PORT AUTHORITY OF ALLEGHENY COUNTY

SUBJECT: North Shore Connector
NSC Train Systems (System Wide)
Contract No. NSC-009

ADDENDUM NO. 5

September 5, 2008

CONTRACT NO.		NSC-009
DWG. NO.	QC151	SHT. 1

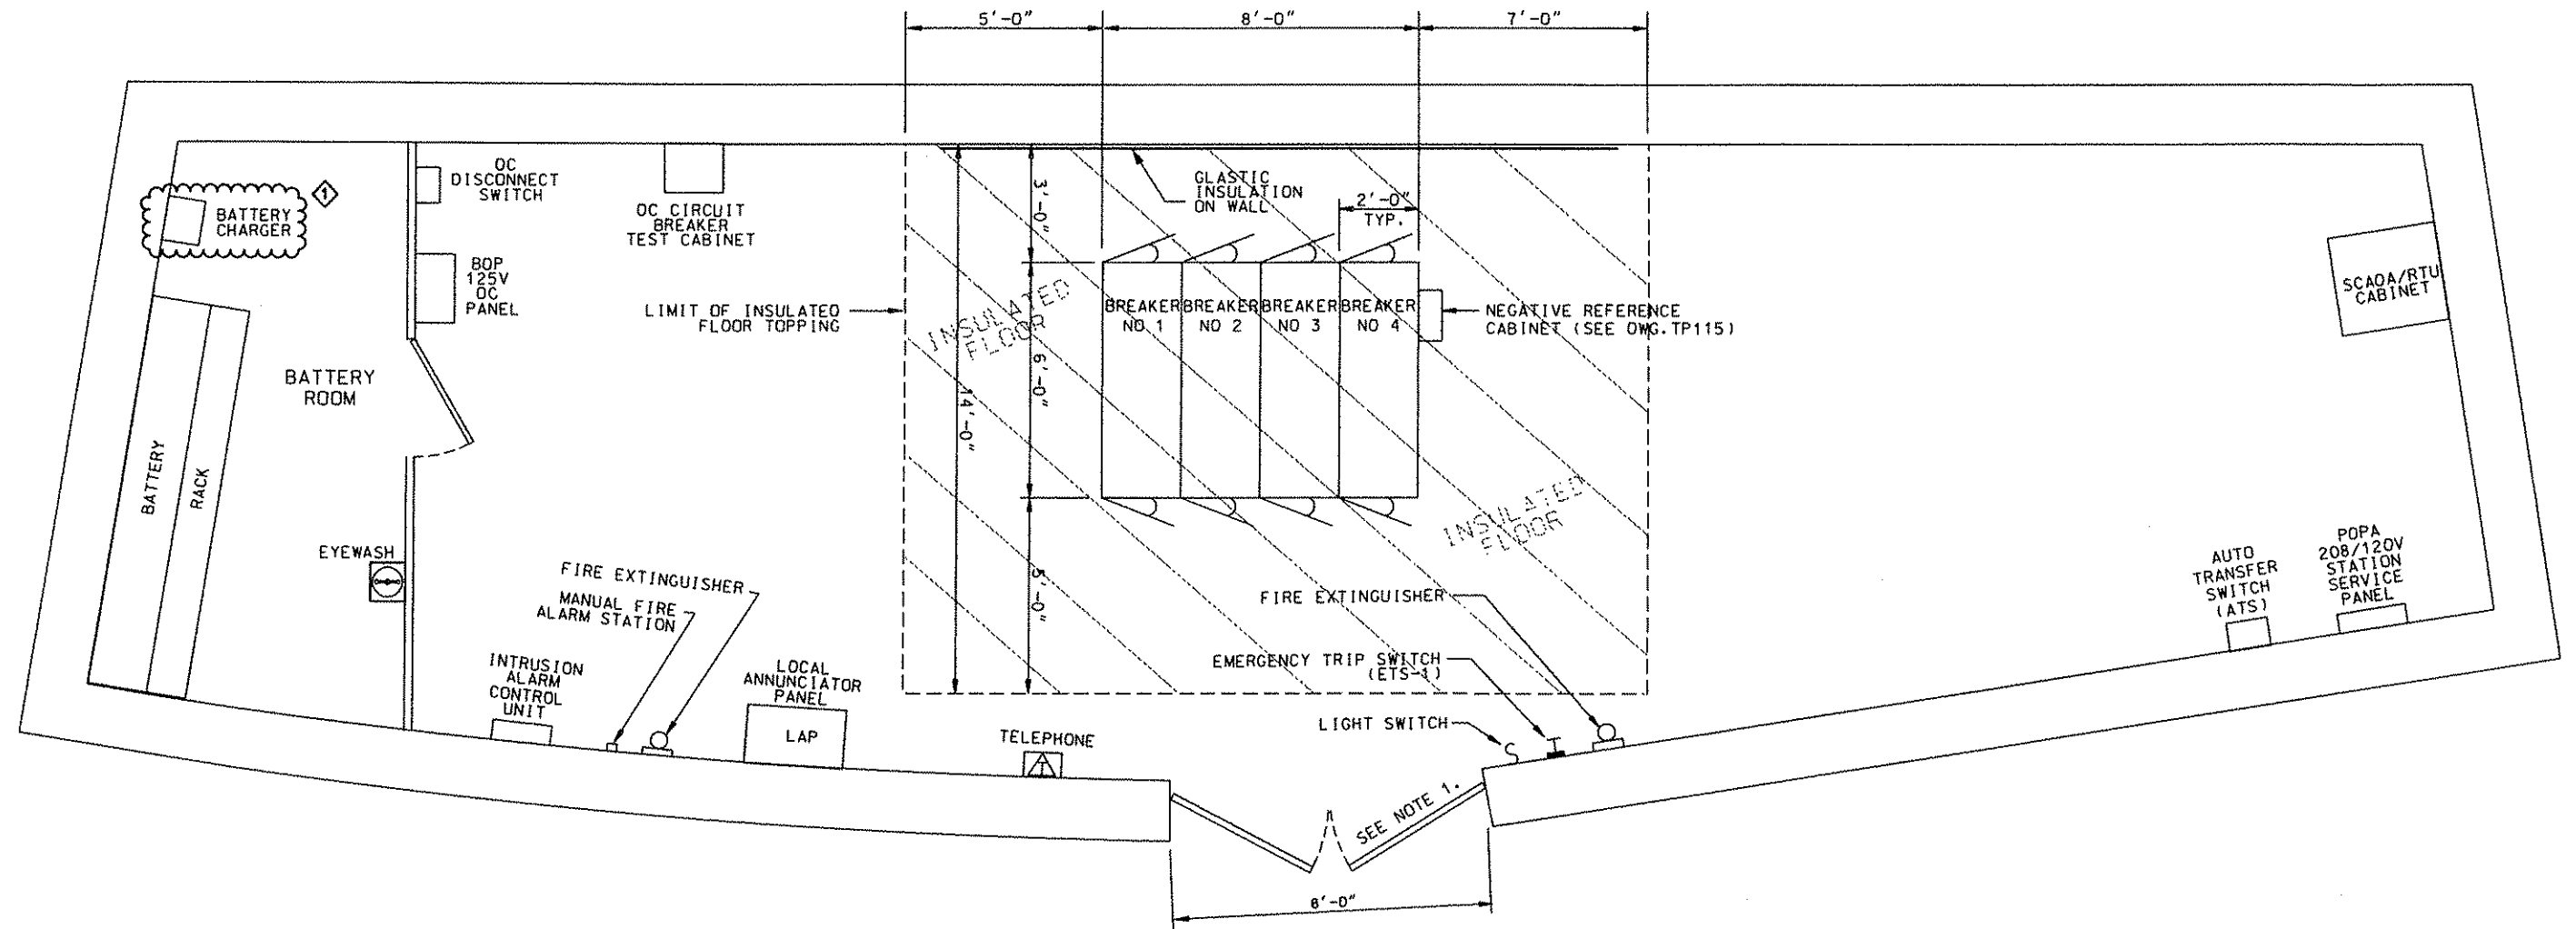
Question 121: Please provide a detail on how you would like the 1000 mcm DC feeders cables connected to the 500 mcm messenger wire. The detail provided is for connecting to a 1000 mcm messenger wire.

Response 121: See revised drawing OC151.

PORT AUTHORITY OF ALLEGHENY COUNTY
PITTSBURGH, PENNSYLVANIA
NORTH SHORE CONNECTOR
SYSTEMWIDE TRACTION POWER AND OCS
GATEWAY TIE BREAKER STATION
EQUIPMENT ARRANGEMENT PLAN
CONTRACT NO. NSC-009
DWG. NO. TP111
SHT. 303

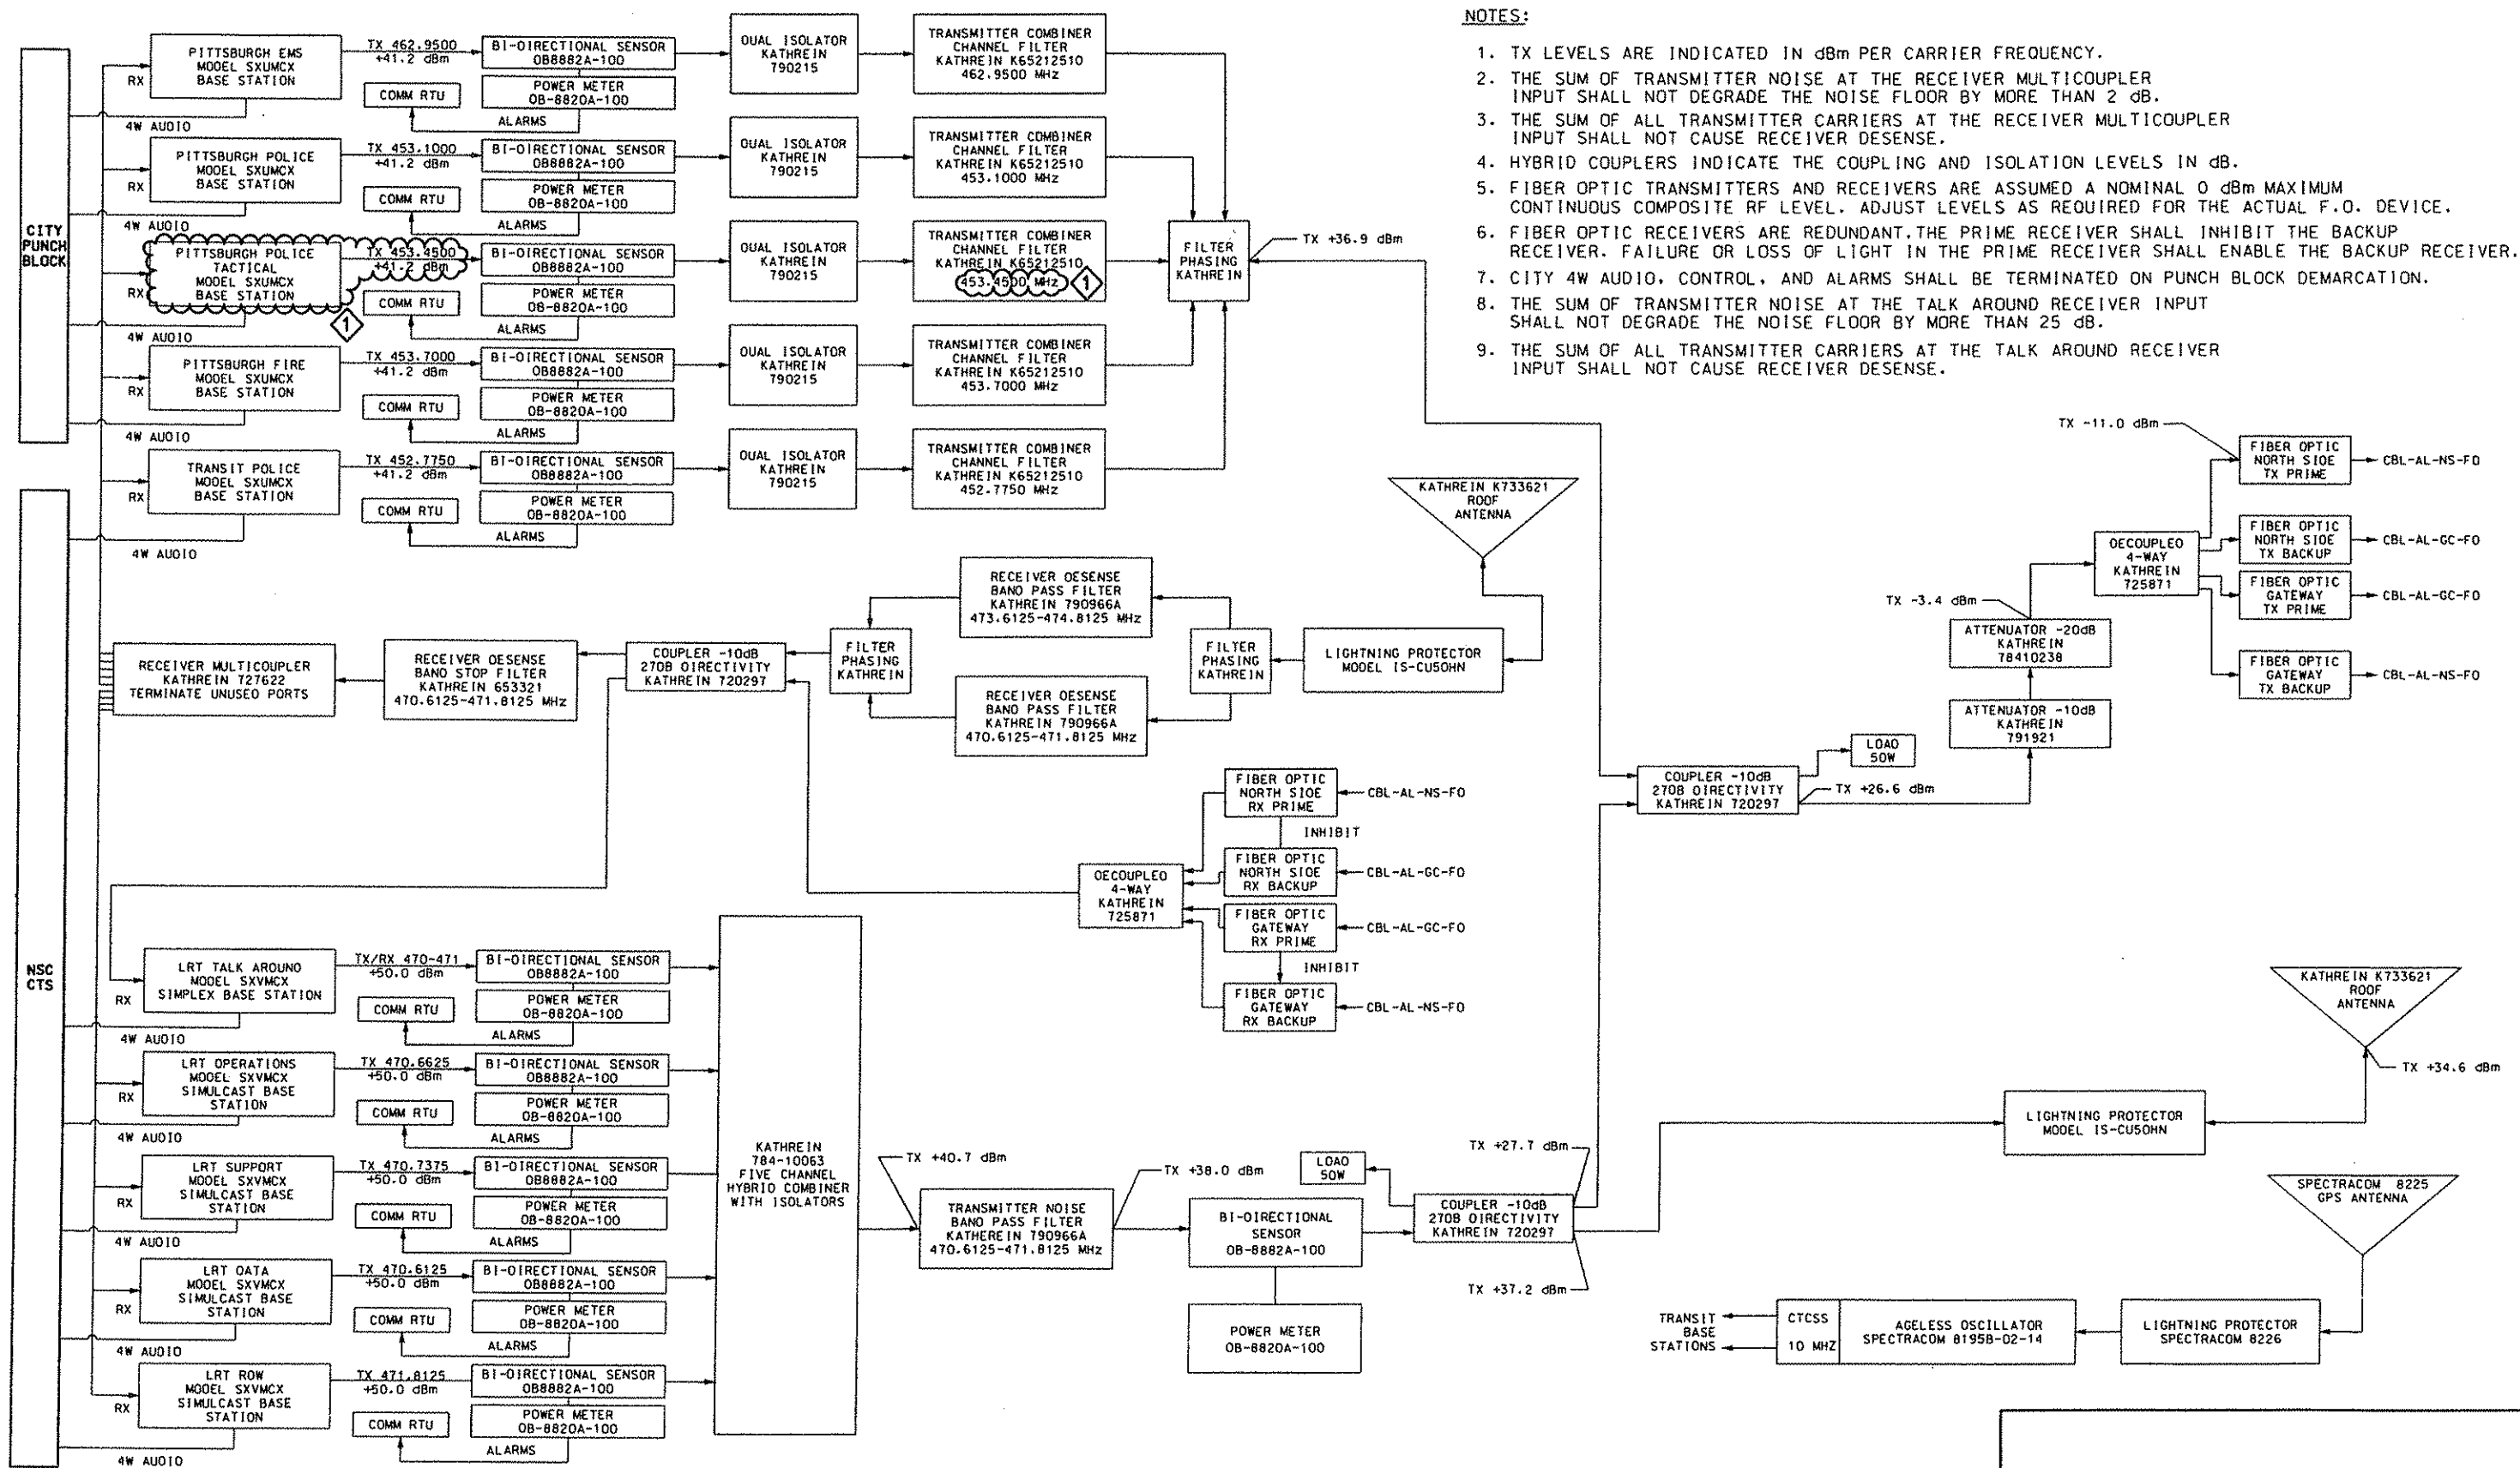
Question 116: Drawing TP111, what is the physical location of the battery charger?

Response 116: Locate battery charger adjacent to battery rack. See revised drawing TP111 in Addendum 5.

PORT AUTHORITY OF ALLEGHENY COUNTY	
PITTSBURGH	PENNSYLVANIA
NORTH SHORE CONNECTOR NSC TRAIN SYSTEM (SYSTEM WIDE) BORED TUNNEL	
ANEMOMETER LAYOUT PLAN AND TYPICAL DETAILS	
Port Authority	CONTRACT NO. NSC-009
DWG. NO. MC-001A	SHT. 616A

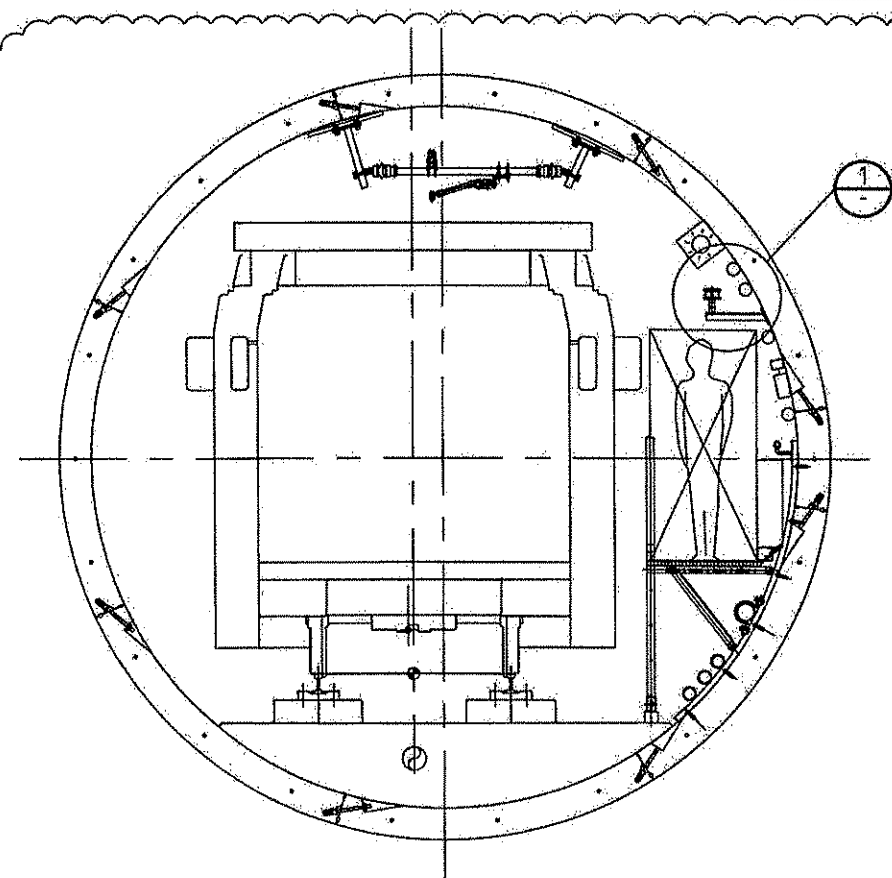
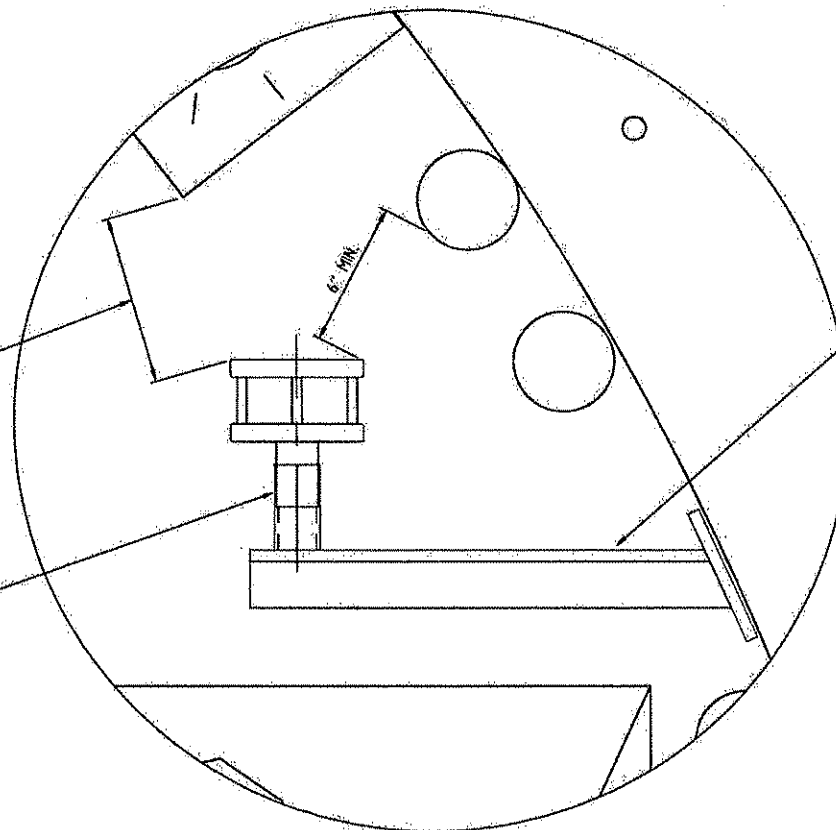
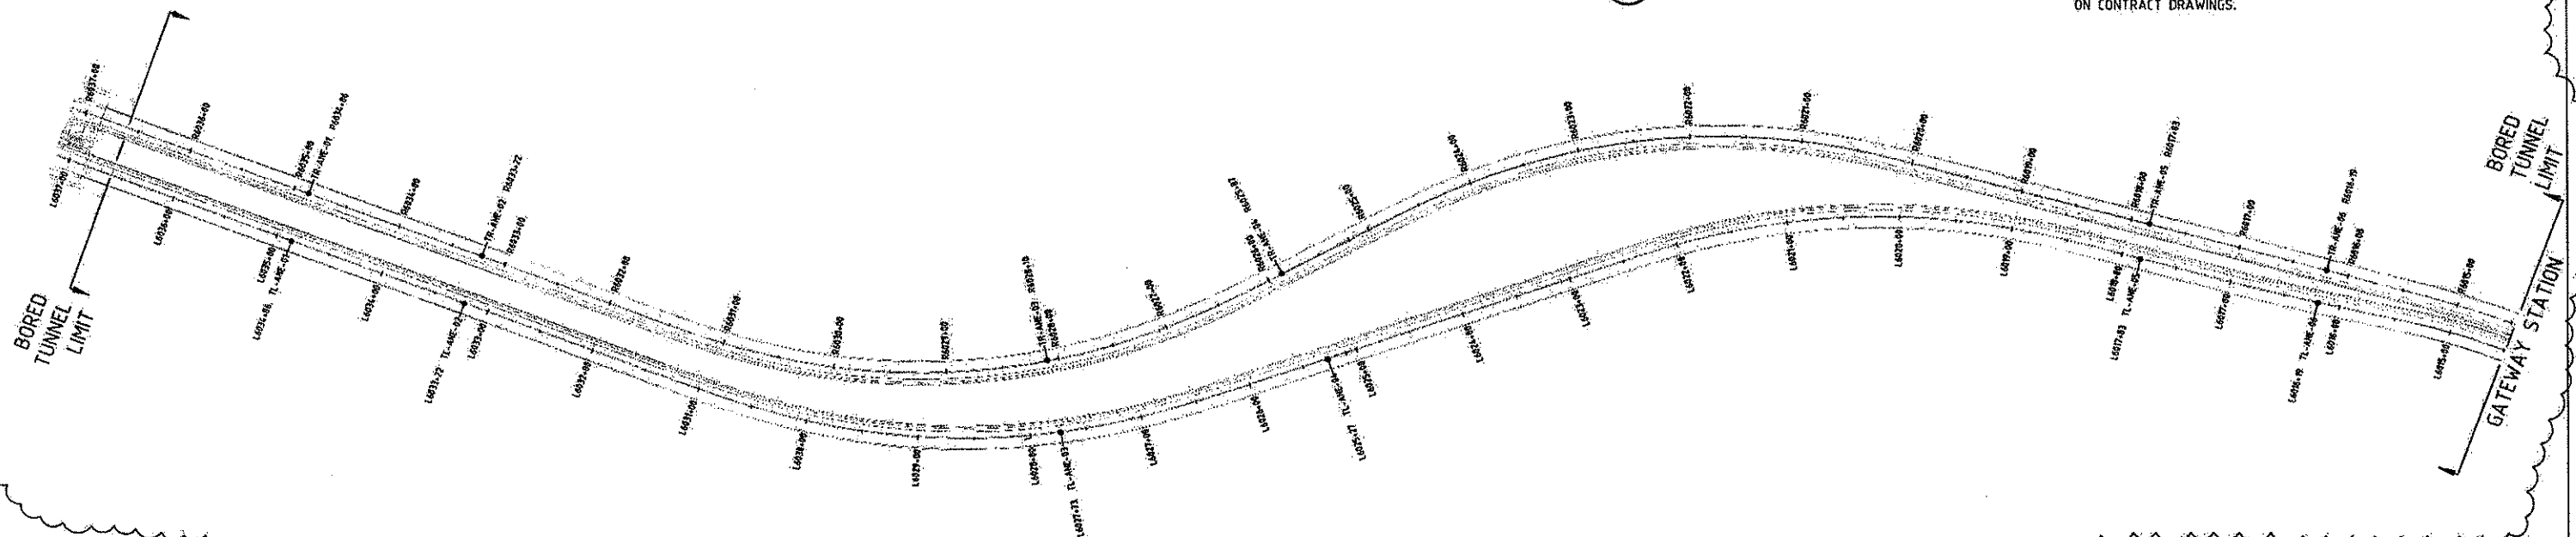
1. Drawing No. GN010, Sheet No. 10. Drawing Modified.
2. Drawing No. OC151, Sheet No. 182. Drawing Modified.
3. Drawing No. TP111, Sheet No. 303. Drawing Modified.
4. Drawing No. TP116, Sheet No. 306. Drawing Modified.
5. Drawing No. CM062, Sheet No. 554. Drawing Modified.
6. Drawing No. CM072, Sheet No. 557. Drawing Modified.
7. Drawing No. CM074, Sheet No. 559. Drawing Modified.
8. Drawing No. MC001A, Sheet No. 616A. Drawing Added.
